Illustrated Parts List - IPL Update

H556

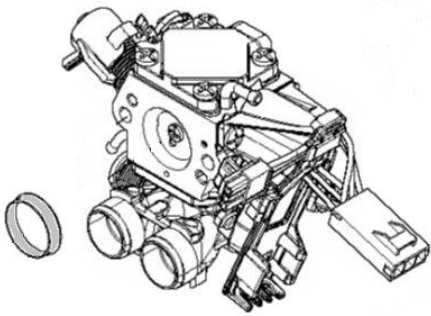
1. A new Inlet pipe, assy 583 96 41-03/-04 have been introduced. The change has been made to ensure the assembly and to avoid leakage.
2. The New Carburetor, kit 501 46 33-06 consist of: New Carburetor ZAMA140059A, a separate support sleeve 582 02 51-01 and AT-instruction.
3. New article number and some minor changes on Air Nozzle due to change of supplier.

1. Carburetor

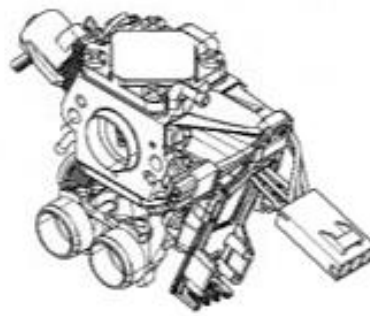
New version

501 46 33-06, ZAMA140059A

Old version

501 46 33-04, ZAMA140056A
